# Carlyle/Eisenhower East Design Review Board September 18, 2007

**REQUEST:** Exemption from DRB condition requiring treatment of north wall of

**LOCATION:** 2321 Mill Road (Eisenhower East)

North side of parking structure

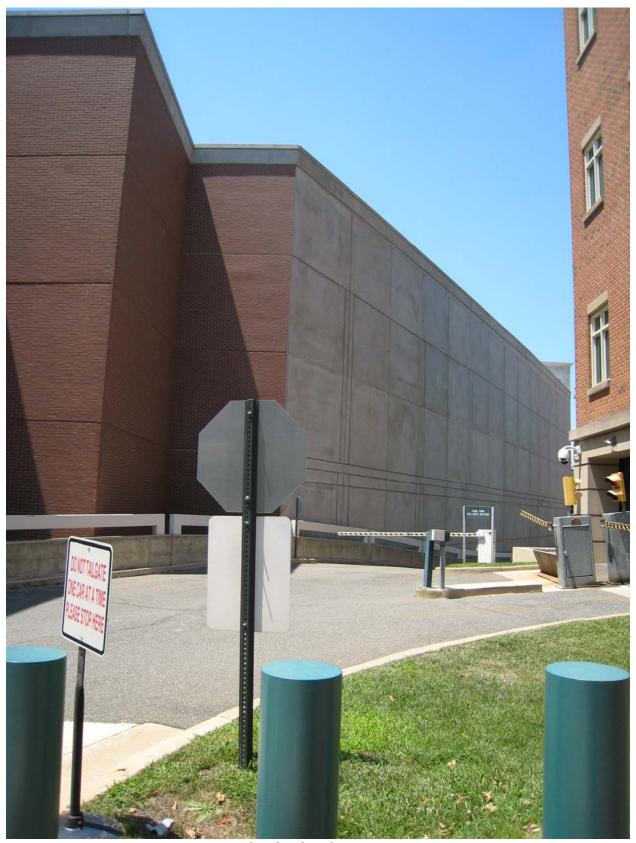
Staff has been to the site to examine the wall in its built state and has also reviewed the pictures and letter from the architect supplied by the applicant. From the site visits and review of the pictures, it appears that the surface of the pre-cast is slightly uneven and in some light the finish of the wall appears blotchy or inconsistent in contrast to the high quality finishes on the remainder of the building. Additionally, the corner condition where the brick wall meets the precast wall is disconcerting and appears unresolved. While Mr. Blair identifies some valid points in his letter, staff still sees value in treating the garage wall to create less of a contrast between the precast and the brick, as previously directed by the DRB.

Staff recommends that the Board reaffirm its original decision and **deny** the applicant's request to leave the garage wall untreated.

**BOARD ACTION:** On a motion by Mr. Lewis, seconded by Mr. Quill, the Carlyle Design Review Board voted to require the applicant to explore treatment options for the wall and return to the Board at a later date with possible solutions. The Board agreed that this outstanding issue should not delay issuance of a permanent Certificate of Occupancy for the parking structure. The motion carried on a vote of 4-0.
